DEVIATION REQUEST AND DECISION FORM

Deviation No. 2 (Revised 2-29-20)

PCD File No. PPR-0199

Project Name : Monument Academy Charter School
Schedule No.(s) : 6100000245
Legal Description : THAT PART OF NW4 LY ELY OF E R/W LN OF HWY 83 EX RD, E S 200 FT OF SE4NW4, EX 0.49 A TO AMERICAN TEL + TEL SEC 15-11-66

Figure 2

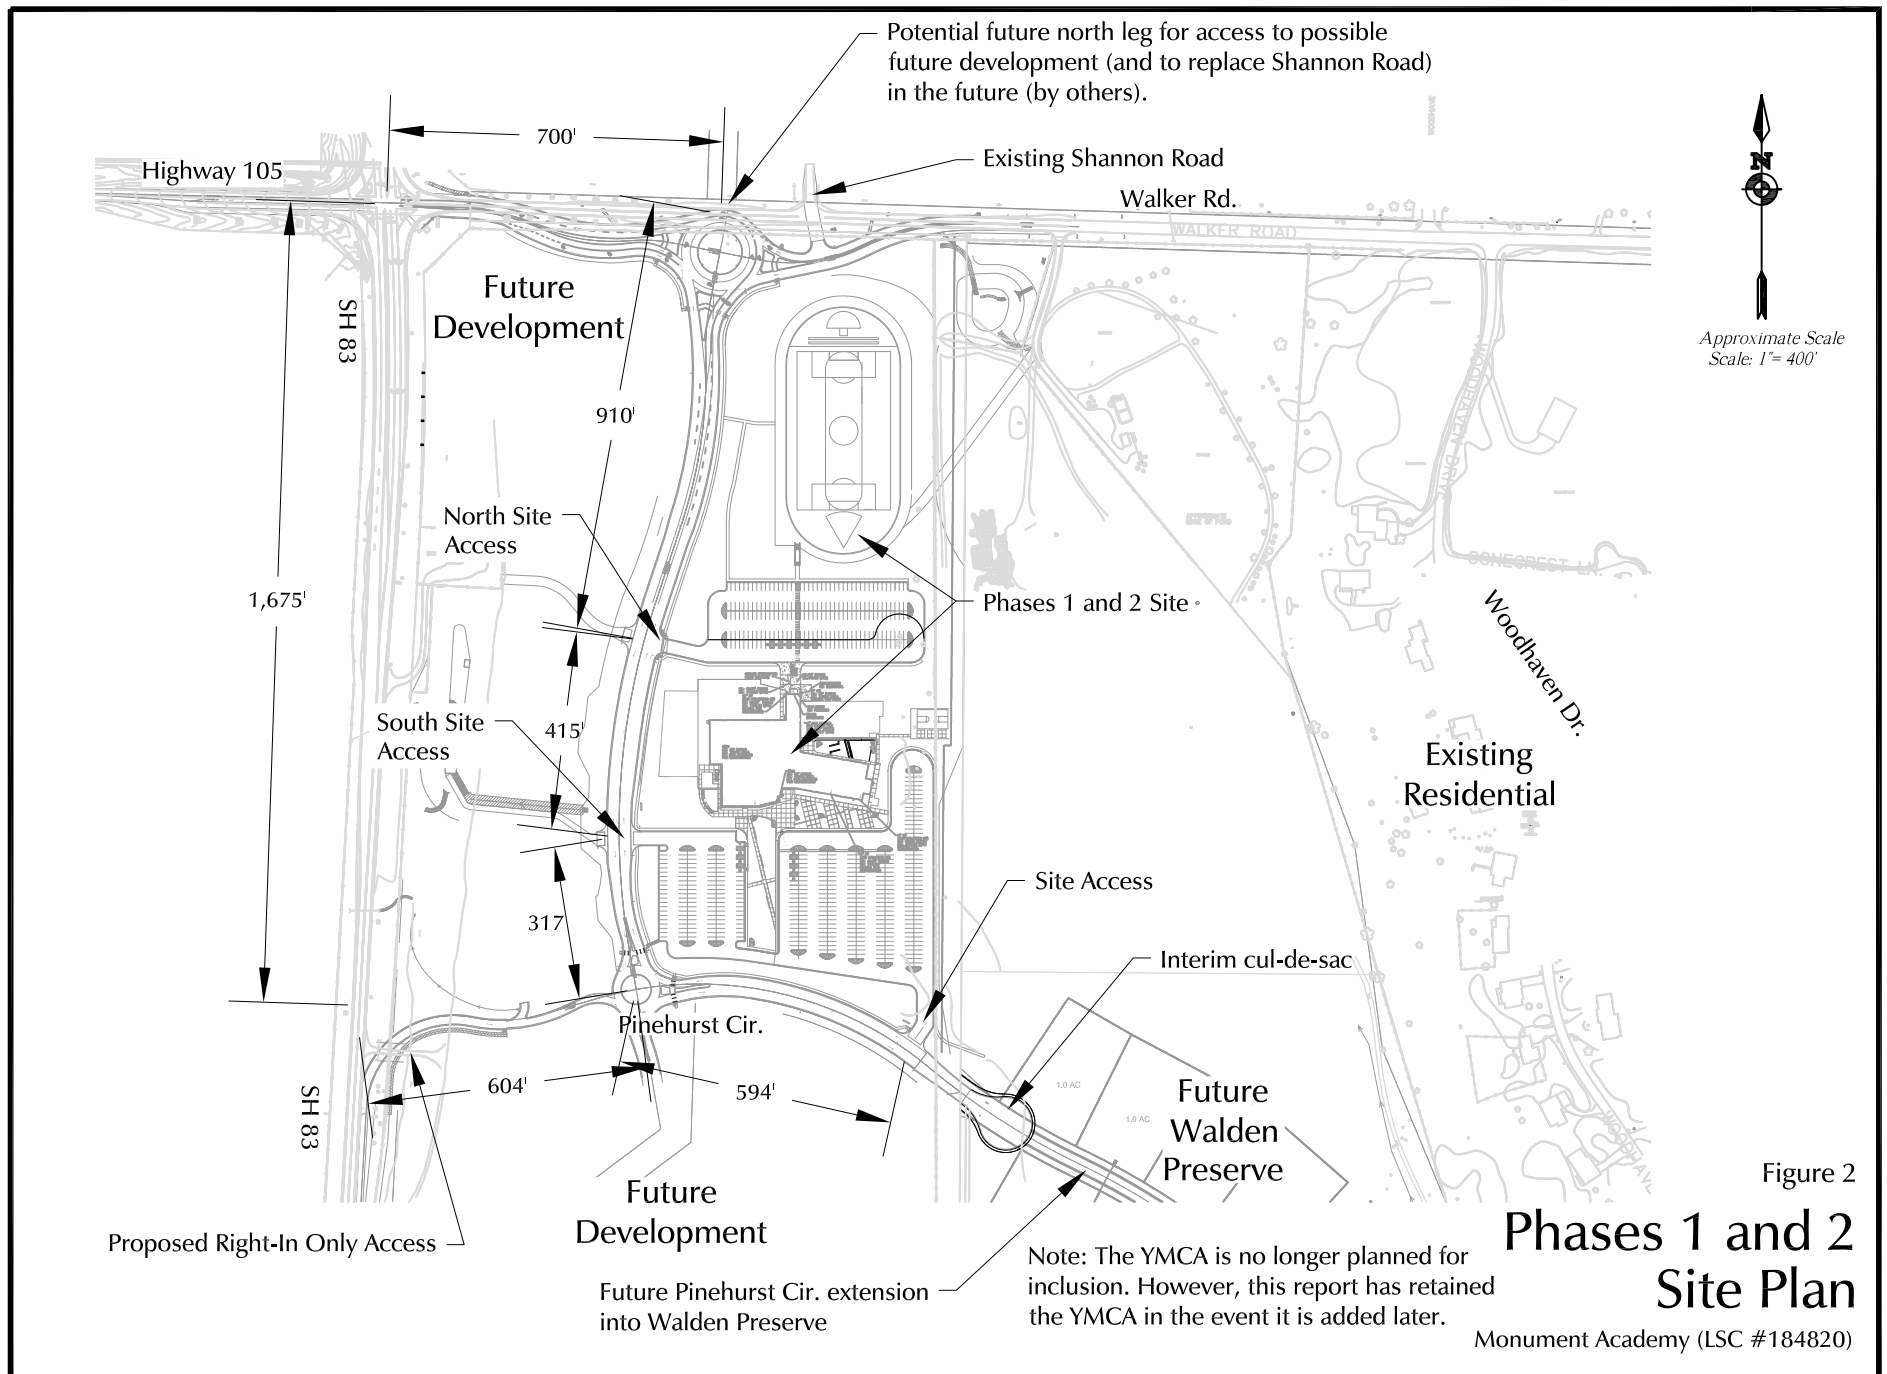
-The proposed access plan is shown on the attached Figure 2 from the TIS Report.

- The proposed school access spacing is based on meeting the criteria contained in ECM Table 2-35 Entering Sight Distance for Driveways. Based on a posted speed limit of 35 miles per hour, the required sight distance for passenger cars and pickup trucks is 350 feet and the required distance for single unit trucks is 455 feet. The deviation would allow for an access to Jane Lundeen Drive 317 feet north of Pinehurst Circle and 415 feet south of the next access point. The attached copy of Figure 2 from the Monument Academy Traffic Impact Study shows the proposed access spacing.

Comparison to ECM Standards: Based on a posted speed limit of 35 miles per hour and assuming a single unit truck as the design vehicle the required entering sight distance for access design is 455 feet. The requested south access location is 317 feet north of Pinehurst Circle and 415 feet south of the next access point to the north. This is 138 feet less than the required distance to the south and 40 feet less than the required distance to the north.

One of the staff comments reads: ***"A roundabout may also be desirable at the northernmost parking lot access, aligning with the future commercial access to the west; address as appropriate."*** Another mini roundabout at the northernmost parking lot access is an option that will be considered with future plans for development on the west side of Jane Lundeen. A mini roundabout at this location may be beneficial to the future development because this type of traffic control would make it easier for traffic exiting that new development to turn left and head northbound on Jane Lundeen. Likely the vast majority of all motorists that

Another County Staff comment reads: **“A right-in/right-out only access may be appropriate for the southern, YMCA parking lot access; address this option in the deviation request.”** Note: the YMCA is not proposed at this time. A right-in/right-out only access would not be practical and is not recommended for the following reasons: 1) the school will need the **southbound left-in** capability at both access points to Jane Lundeen. It would not be reasonable to force all traffic that would otherwise turn left at this access to the southeast corner access (or make a U-turn in the mini roundabout). This would unnecessarily add volume to the mini roundabout. The TIS recommends a circulation plan which includes a southbound left and a westbound right out at this access. Maintaining the full movement capability at this intersection would allow for maximum flexibility for the school circulation plan. Also, except for the peak periods before and after school, the turning volumes at this access would be relatively light.

This request has been determined to have met the criteria for approval. A deviation from Section 2.2.1.B/D, 2.3.2 of the ECM is hereby granted based on the justification provided.
